Access Compliance Report Public Rights-of-Way (Curb Ramps)

Main Street: KENILWORTH_DR Cross Street: WALLINGSFORD_RD Location: NW

ADA ID: RPRK211215143320 Ramp Type: Type 1 - Perpendicular Diagonal Initial Pass/Fail: Fail Overall Compliance: No Severity Score: 2

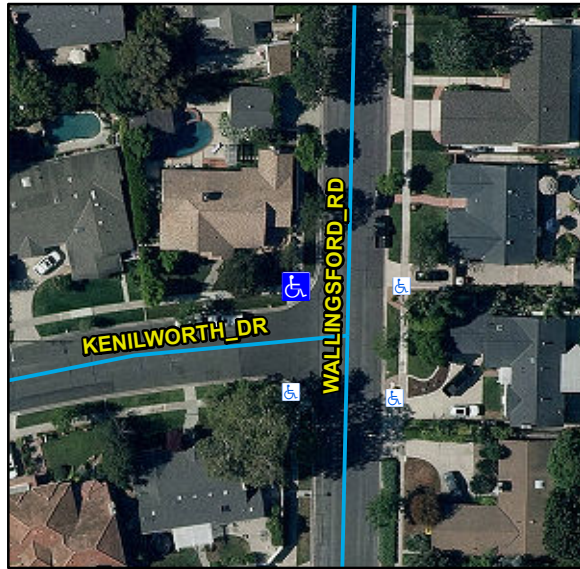
R304.2.2, R204.3, R304.5.3, STD 1115

Remove & Replace Curb Ramp With Two New Directional Ramps or Equivalent.
